Draft decision

Powercor electricity distribution determination

Attachment 2 – Capital expenditure

September 2025

Table 2.1 AER's draft decision on Powercor's total net capex forecast for 2026–31 (\$2025–26, million)

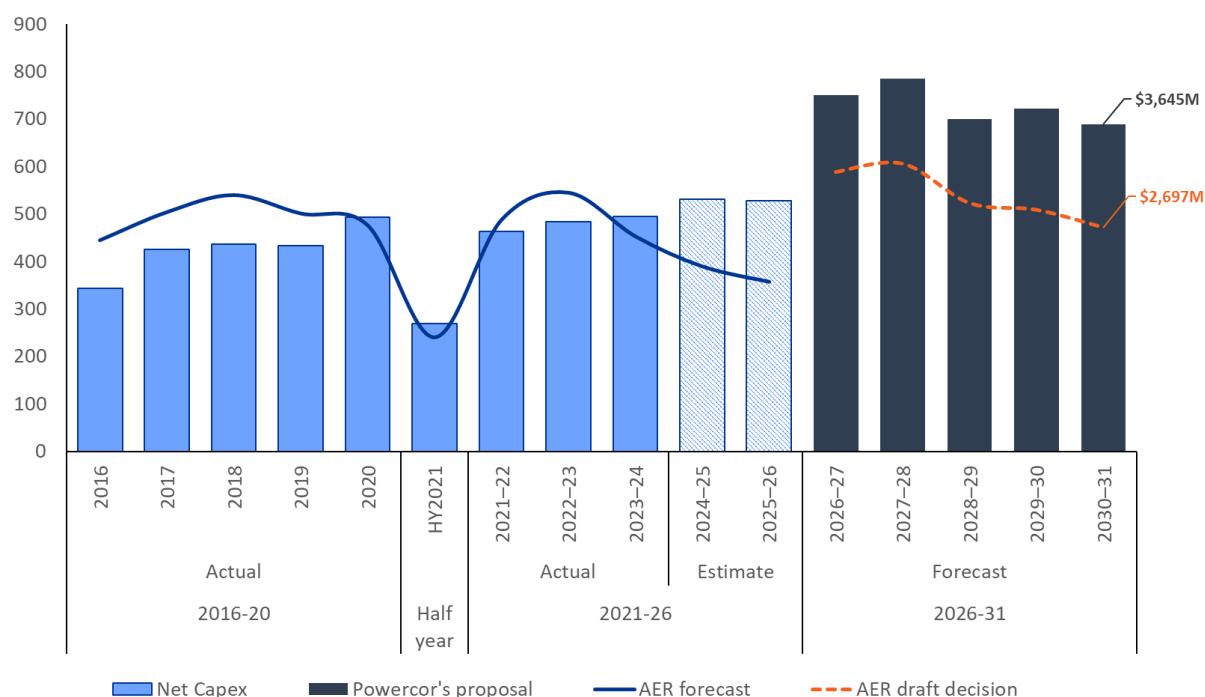
Our draft decision is to not accept Powercor's proposed total forecast capex of \$3,644.9 million (\$2025–26) for the 2026–31 period. This is because we are not satisfied that it reasonably reflects the prudent and efficient costs to maintain the safety, reliability and security of the network.

Our substitute forecast is \$2,696.9 million, which is 26.0% below Powercor's forecast. We consider this forecast will provide for a prudent and efficient service provider in Powercor's circumstances to meet the capex objectives.
